## SYDNEY NORTH PLANNING PANEL COUNCIL ASSESSMENT REPORT

<b>Panel Reference</b>	PPSSNH-483
<b>DA Number</b>	Mod2024/0134
<b>LGA</b>	Northern Beaches
<b>Proposed Development</b>	Modification of Development Consent DA2021/1912 granted for alterations and additions to an existing building for a mixed use development including seniors housing and boarding house, stratum subdivision and strata subdivision.
<b>Street Address</b>	<p>Lot 45 DP 12578, 8 Palm Avenue NORTH MANLY NSW 2100</p> <p>Lot 22 DP 865211, 389 Pittwater Road NORTH MANLY NSW 2100</p> <p>Lot 1 DP 544341, 2 - 4 Lakeside Crescent NORTH MANLY NSW 2100</p> <p>Lot 46 DP 12578, 2 - 4 Lakeside Crescent NORTH MANLY NSW 2100</p> <p>Lot 47 DP 12578, 2 - 4 Lakeside Crescent NORTH MANLY NSW 2100</p> <p>Lot 48 DP 12578, 2 - 4 Lakeside Crescent NORTH MANLY NSW 2100</p>
<b>Applicant</b>	Link Wentworth Housing Limited
<b>Date of DA lodgement</b>	25/03/2024
<b>Number of Submissions</b>	8
<b>Recommendation</b>	Approval

Northern Beaches Council is in receipt of Modification Application (MOD2024/0134) seeking to modify development consent DA2021/1912 for 'Alterations and additions to an existing building for a mixed use development includi

**Figure 2 - Proposed extent of roof plant under this modification application, roof plan.**

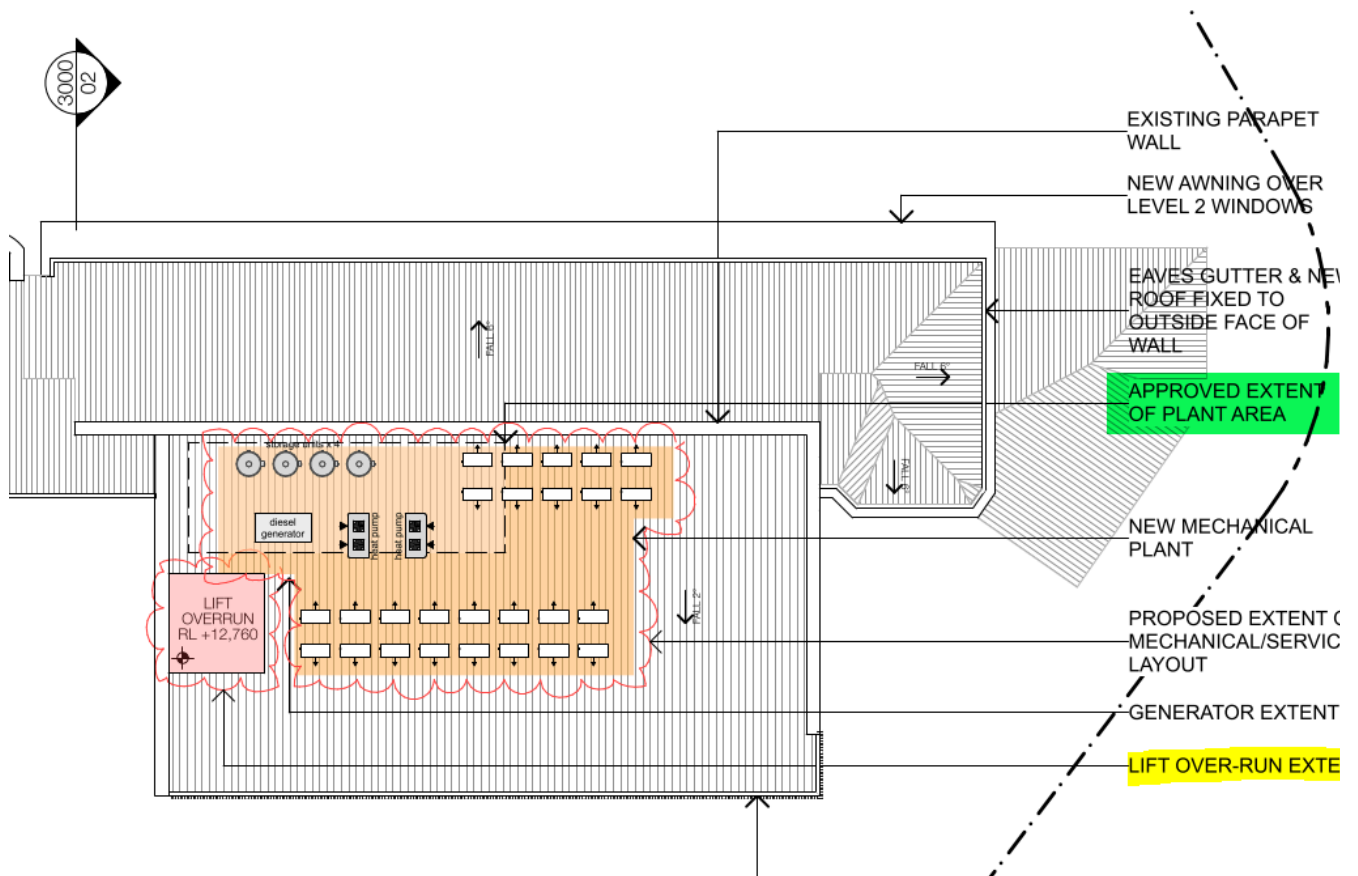
The modification application seeks to formalise the design and detail of the mechanical plant. The modification also includes a lift overrun which will breach the 8.5m height limit, however, will be lower than the approved mechanical plant. See extract below of the proposed roof plant:

The proposed extent of roof plant is no higher than the approved roof plant and the tallest plant is located in the same position as the approval. The additional air-conditioning units, although extending beyond the footprint of the approved plan, are low scale structures which will be hidden from view by the roof parapet. The roof plant has been appropriately positioned away from the adjoining nearest adjoining property.

The lift overrun is centrally located within the site and is proposed at RL12.76. This will sit slightly higher than the approved roof parapet which sits at RL12.65 (120mm). However, the lift overrun is centrally located within the roof plan and will not be visually discernable from the street or surrounding properties.

As such, whilst there are features of the modified plans that site above the 8.5m building height, these features remain consistent with the overall maximum height of the building as approved and do not increase the maximum breach of the building height approved under the original application. Furthermore, it is not considered necessary to require screening of the plant area under this modification application as the proposed mechanical plant is no higher than that approved under the original application, with the tallest roof plant nominated in the same position as approved.
